in the matter of: applications for resource consents and archaeological authorities and notices of requirement by the New Zealand Transport Agency Waka Kotahi to develop a rapid transit link and associated infrastructure and connections between Brigham Creek and Auckland City centre, alongside State Highway 16, known as 'North West Rapid Transit'

Second Statement of Evidence of Gregory Maitland Sheppard for New Zealand Transport Agency Waka Kotahi

- 4 My evidence responds to Technical Specialist Memo – Groundwater dated 18 May 2026 authored by Mr Richard Simonds (*Groundwater Memo*) at Appendix 19 of the Auckland Council comments.

Figure 1 – Groundwater drawdown at the Point Chevalier station for the unrestricted groundwater seepage and the “leaky” secant piling scenarios

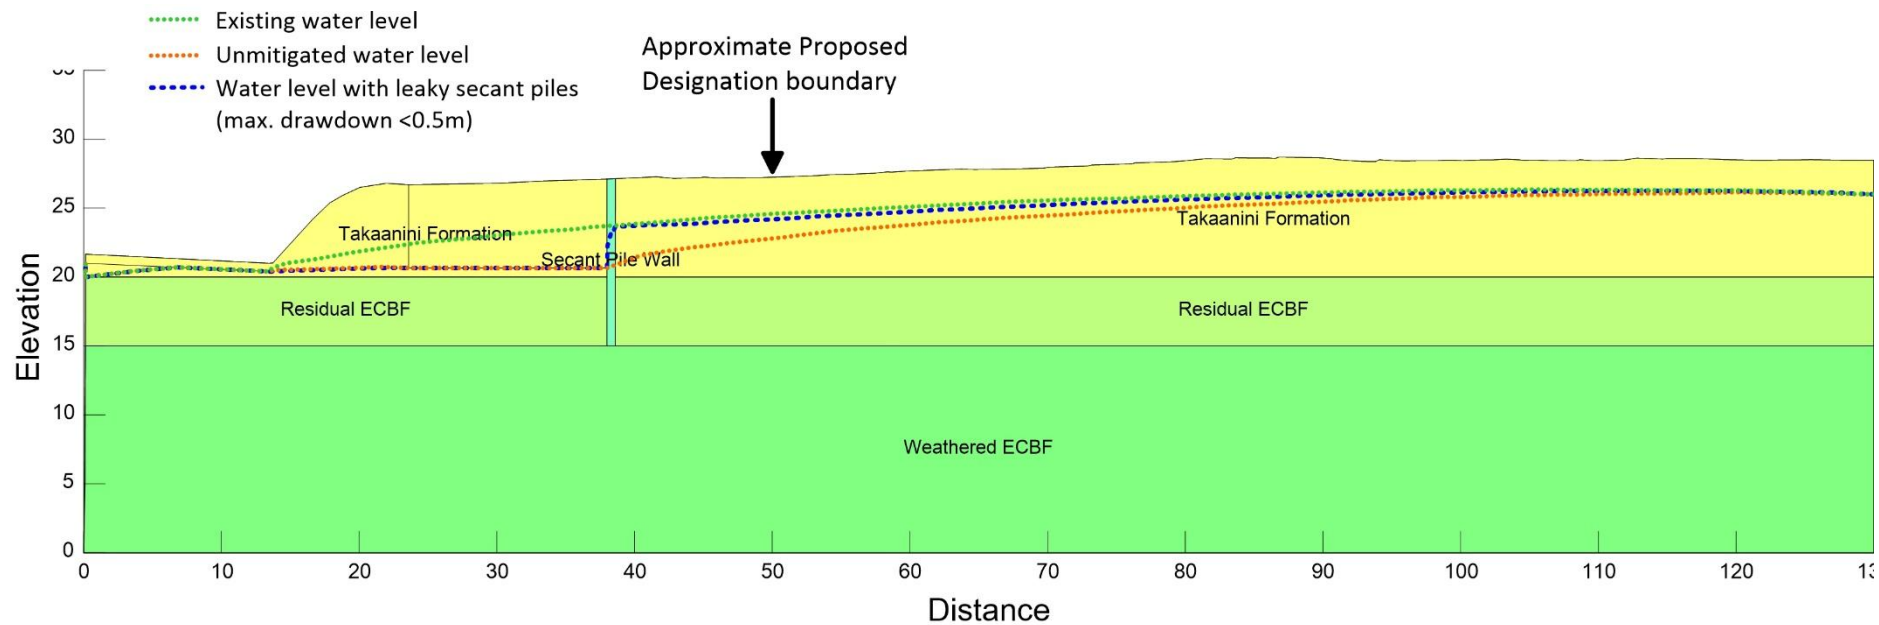
It is my opinion that the proposed works may not meet AUP (OP) Standard E7.6.1. 10 (3) at the location of the proposed Point Chevalier station, as the maximum unmitigated drawdown at the proposed Designation Boundary is predicted to be greater than 2.0 m. It is also my opinion that the proposed works may not meet AUP (OP) Standard E7.6.1. 10 (3) at the location of the proposed Fred Taylor Drive underpass.

- 8 As the final design of the retaining walls is unknown, I adopted a conservative secant pile wall design incorporating 0.6 m diameter piles with a nominal hydraulic conductivity of $1\text{E-}8$ m/s, which allows for minor discontinuities or imperfections in the secant piling that may have potential to leak (ie a “leaky” secant piling scenario). For comparison, the secant piling design adopted for a nearby recent project² (located in similar geological formations near Point Chevalier) adopted secant pile walls of 0.9 m diameter and a hydraulic conductivity of $1\text{E-}10$ m/s, which for the purposes of a dewatering assessment is practically impermeable. The “leaky” secant piling scenario I adopted has an approximately two orders of magnitude greater equivalent conductance,³ and therefore still remains relatively conservative.

- 9 Figure 1 shows the modelled water levels for the original unmitigated scenario (orange) and the “leaky” secant piling scenario (blue). In the “leaky” secant piling scenario, the maximum groundwater drawdown is approximately 0.4 m, with approximately 0.2 m of drawdown at the Proposed Designation boundary. I consider this drawdown is well within natural seasonal variation and will not result in consolidation settlement.

- 11 In my opinion, the final design of the Project (which is likely to incorporate pre-installed secant pile walls or diaphragm walls where necessary) will ensure the Project will not cause groundwater drawdown that exceeds 2 m at the Proposed Designation boundary, and, as indicated above, any groundwater drawdown is likely to be substantially less than 2 m.

Figure 3 – Westgate Station to Fred Taylor underpass long-section

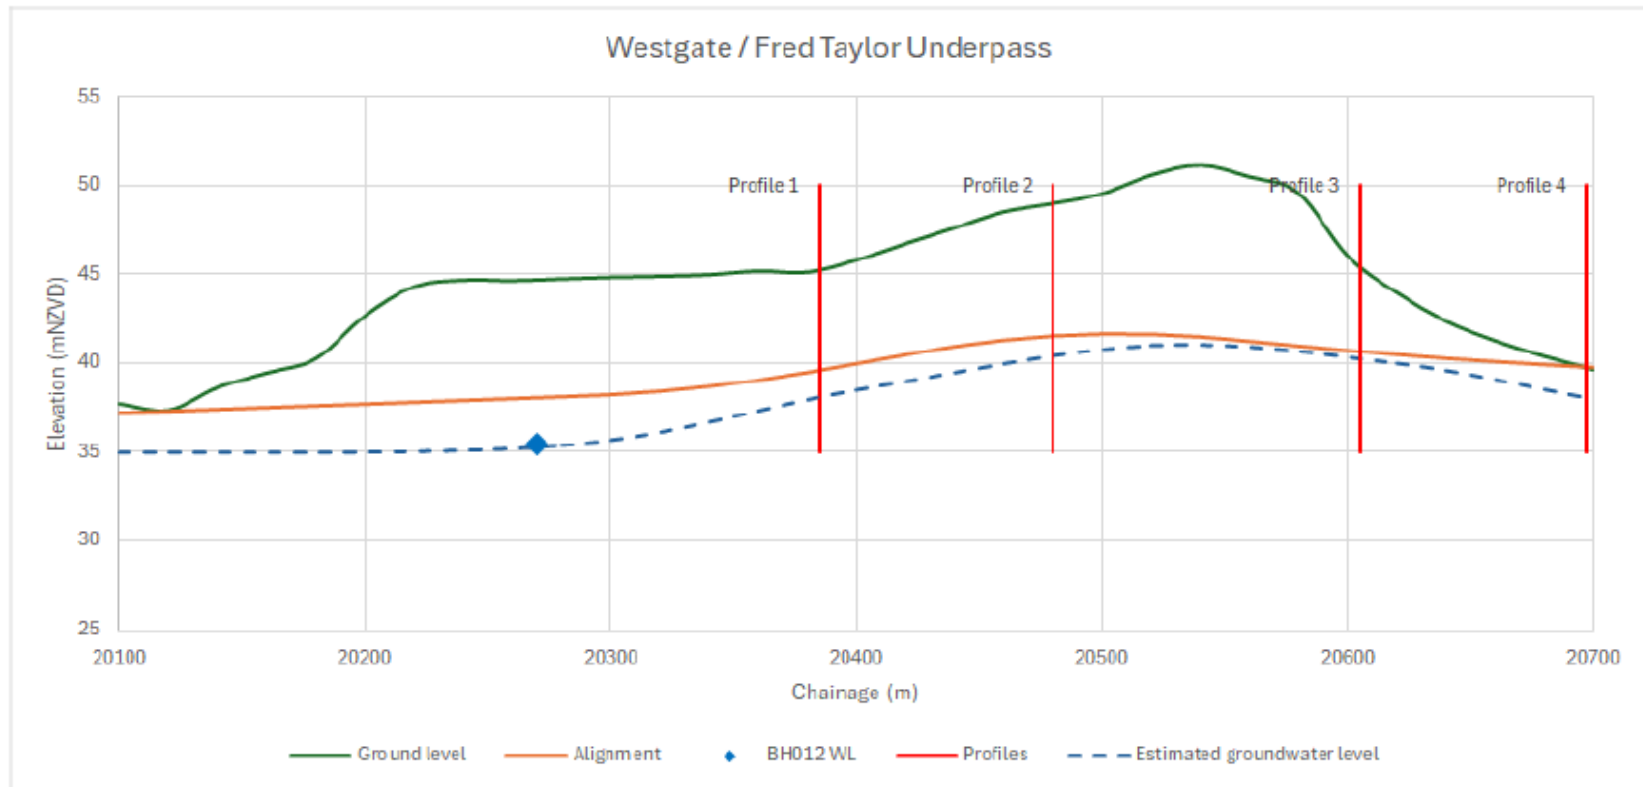
It is my opinion that the assessment of groundwater drawdown at the proposed Fred Taylor Drive underpass, undertaken by the Applicant's Hydrogeologist – Greg Sheppard from Jacobs New Zealand, is invalid, because it is not informed by measured groundwater levels in a standpipe piezometer in an appropriately located borehole.

- 13 A long-section from Westgate Station and incorporating the Fred Taylor Drive Underpass is shown on Figure 3 above, and also shows the locations of the profiles and the observed groundwater elevation at BH012. The existing motorway to the east and the low-lying ground to the south of Fred Taylor Drive, combined with the observed groundwater levels to the north (BH012) limit the potential groundwater elevation in the vicinity of the underpass. If groundwater is encountered, it would most likely be associated with a localised elevated or perched water table that would not result in appreciable propagation of groundwater drawdown. Interception of a localised elevated or perched water table is unlikely to result in drawdown greater than 2 m at the Proposed Designation boundary, even under the unmitigated scenario.

- 16 In my opinion, I have sufficient information on the groundwater levels in the vicinity of the Fred Taylor Drive underpass based on interpretation of ground elevations surrounding the underpass and observed groundwater levels at BH012. This interpretation indicates that the potential for encountering elevated groundwater levels that would result in significant drawdown propagation is low, as is risk to the surrounding environment from drawdown or consolidation settlement effects, even when considering the unmitigated scenario.
- 17 I do not consider a borehole in the exact location of the Fred Taylor Drive underpass to be necessary for the assessment of groundwater and settlement effects. I have sufficient information to apply hydrogeological judgement and the potential risk to surrounding buildings is very low as I have explained above.
